REMARKS

IN THE DRAWING

FIG. 1

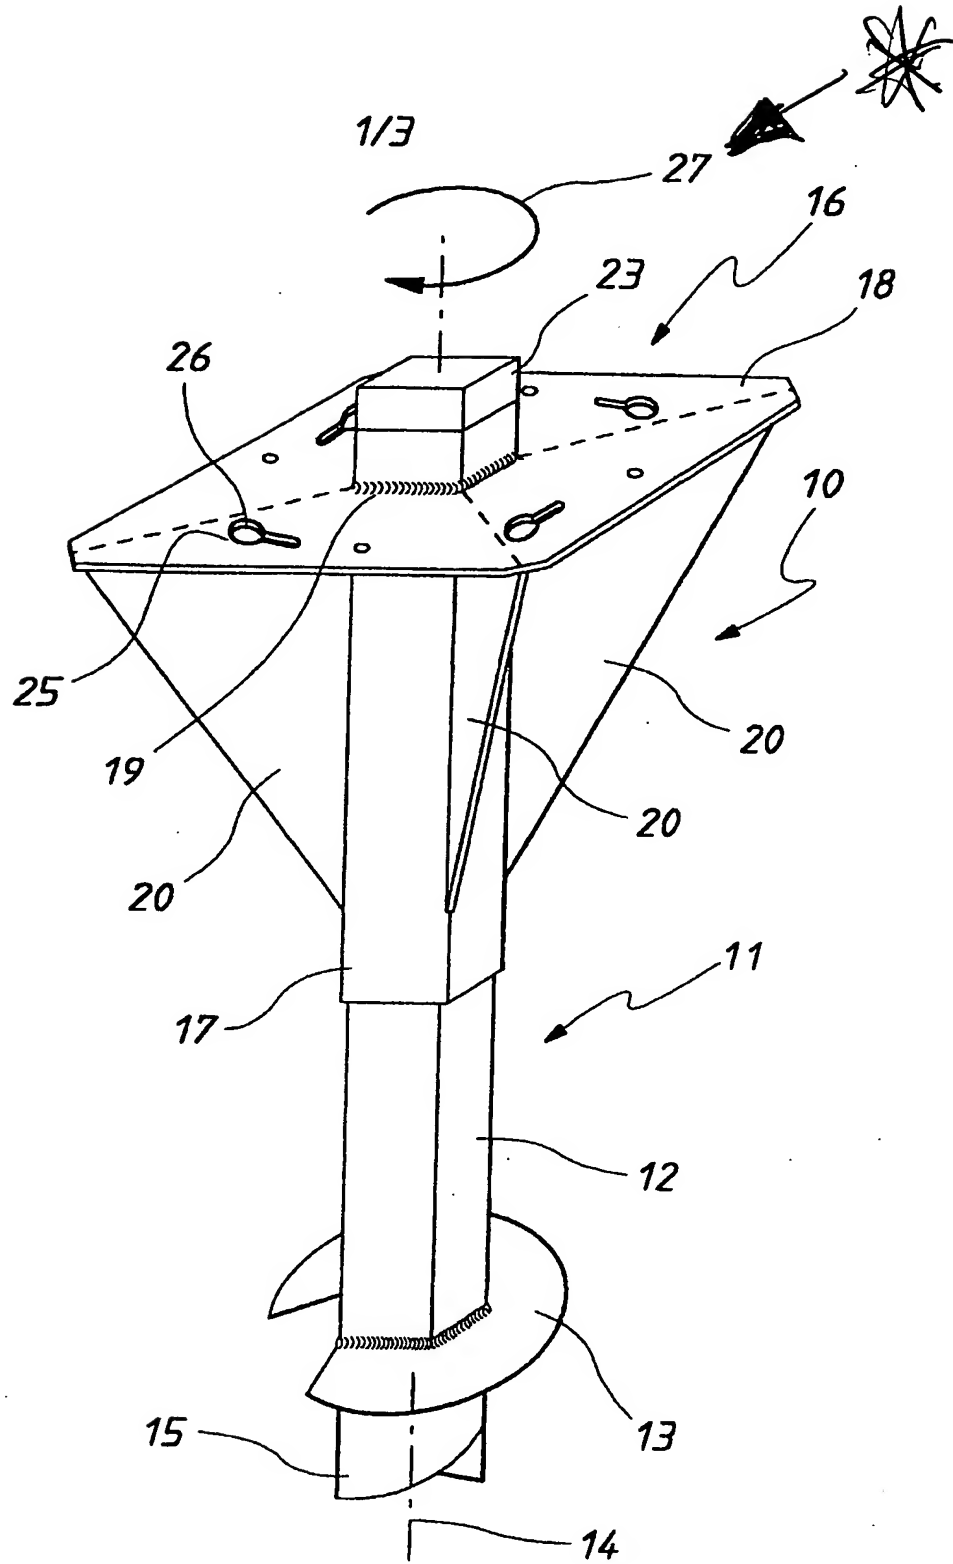
REPLACEMENT SHEETS of Figs. 1 and 2 are attached to add reference character 27 to Fig. 1 and replace a reference character 23 in Fig. 2 with 41 in correspondence with amendment of page 3 of the specification above and Annotated Sheets attached.
